# **Manual Supplement**

Manual Title:381 CalibrationPart Number:Web OnlyPrint Date:December 2010Revision/Date:1, 6/12

Supplement Issue:4Issue Date:4/17Page Count:3

This supplement contains information necessary to ensure the accuracy of the above manual.

Figure 7. Current Test Simulated Voltage

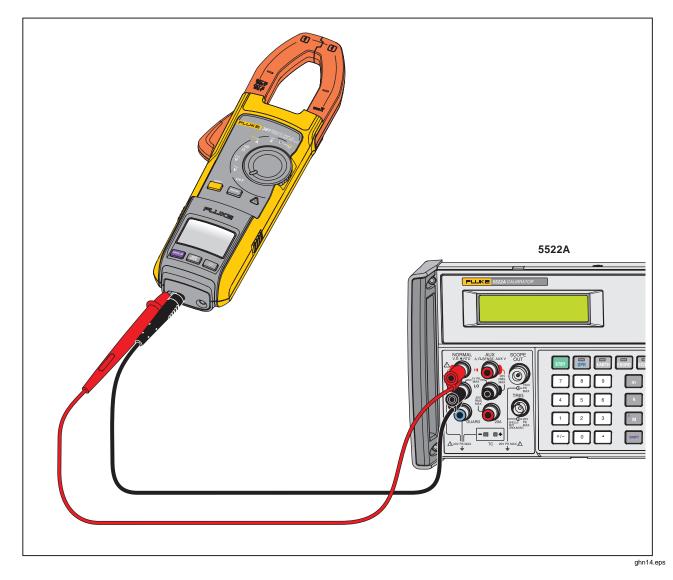
On page 14, replace Figure 7 with:

Figure 5. Performance Test Connections for AC Voltage, DC Voltage, and Frequency

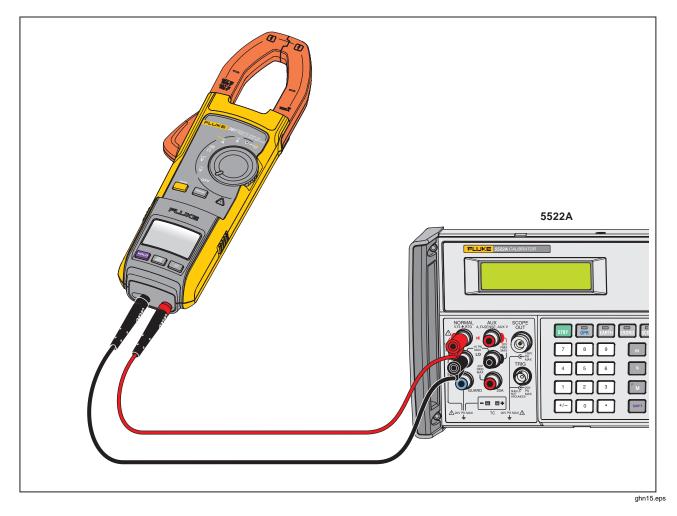
On page 10, replace Figure 5 with:
